Lawrence Livermore National Laboratory

SUBJECT: Transmittal of Two Letter Reports

SUBJECT: Origin of Brine in the San Andres Formation, Evaporite Confining System, Texas Panhandle and Eastern New Mexico, by A. R. Dutton, Geological Society of America Bulletin, v 99, p 103-112, July, 1987

SUBJECT: Stress Orientation Determination from Fault Slip
Data in Hampel Wash Area, Nevada and its Relation to
Contemporary Regional Stress Field , by Virgil A. Frizell, Jr.
and Mary Lou Zoback, Tectonics, V. 6, No. 2, p 89-98

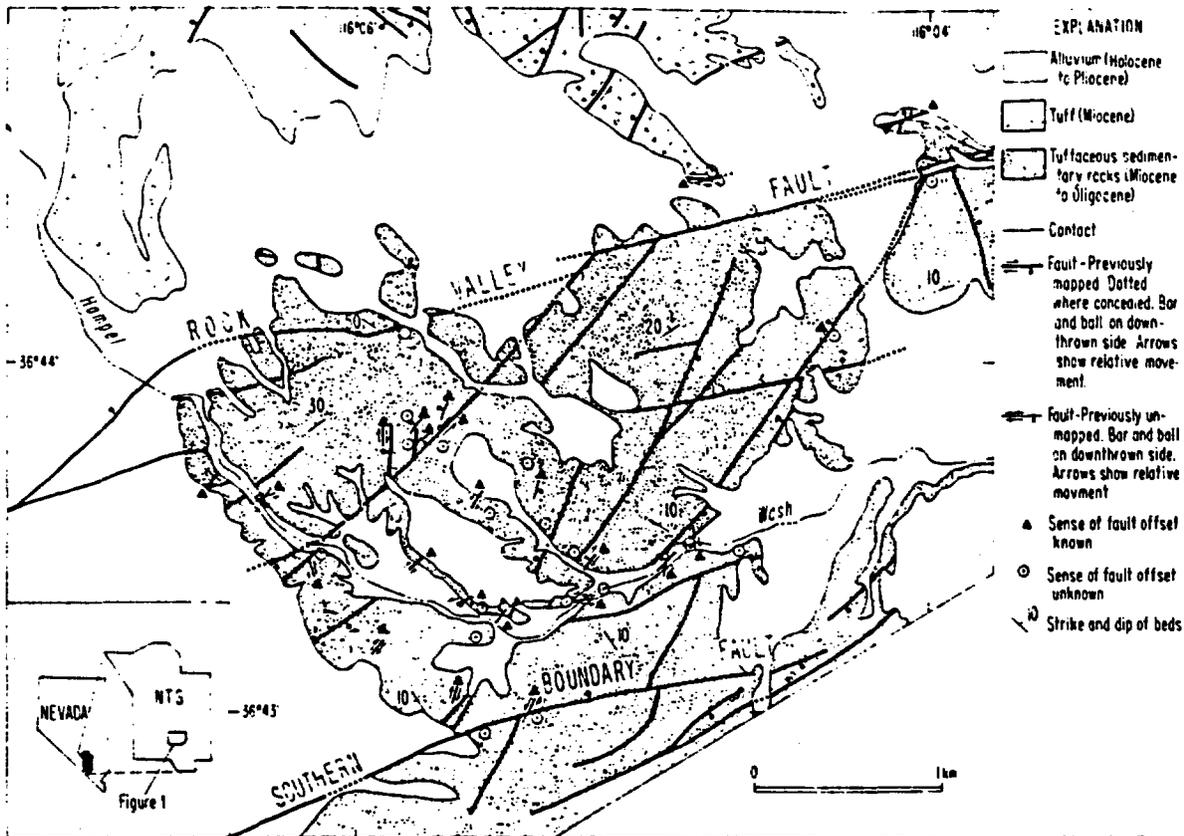
Hampel Wash is located in the northwest corner of the Camp Desert Rock quadrangle, Nevada (USGS, GQ 726) geologic map. The area under consideration is bounded on the northwest by the Rock Valley fault and on the southeast by a parallel left lateral fault (Fig. 1).
